# McLaren Speedtail – Replace Auxiliary USB Board

**Bulletin type:** Service Campaign Bulletin  
**Reference number:** SCB 23 M 002  
**Attention:** Retailer Service Managers and Retailer Technicians  
**Affected vehicles:** McLaren Speedtail  
**Situation:** Installed part cannot be used  
**Procedure:** To action affected vehicles during next Retailer visit. Please refer to the information outlined in this document to replace the auxiliary USB board  
**Date:** 11<sup>th</sup> March 2021

Auxiliary USB board (1)

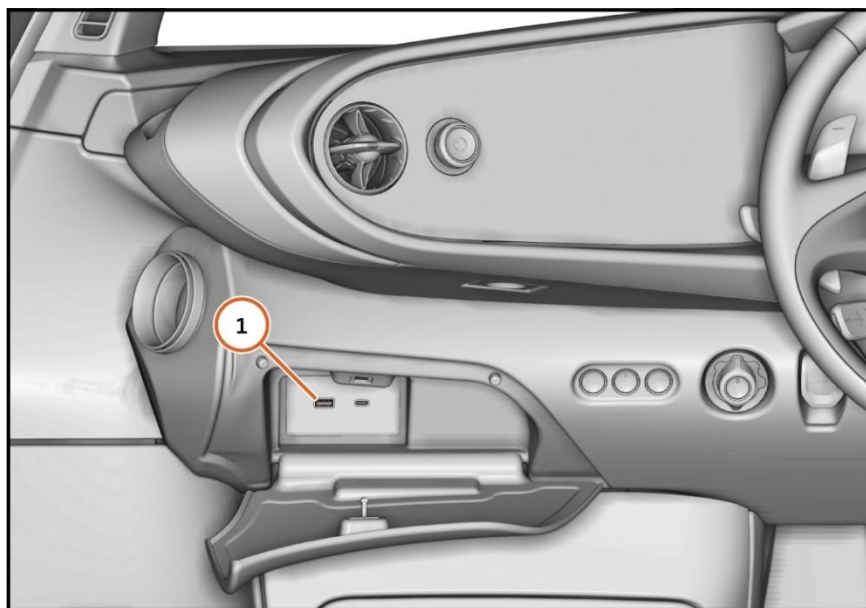
A known number of McLaren Speedtail vehicles were fitted with auxiliary USB boards with a blanking cover installed over them to prevent usage. A new part has now been released for installation in the affected vehicles, so that the functionality can be utilised.

The below part is required to action this repair, which can be ordered via Unipart.

Part Number	Part Description	Quantity Required
16MB225CP	Auxiliary USB board	1

To perform the required work, follow SIS document: GA-RM-09M021-07-001 - Remove/Install Auxiliary USB board
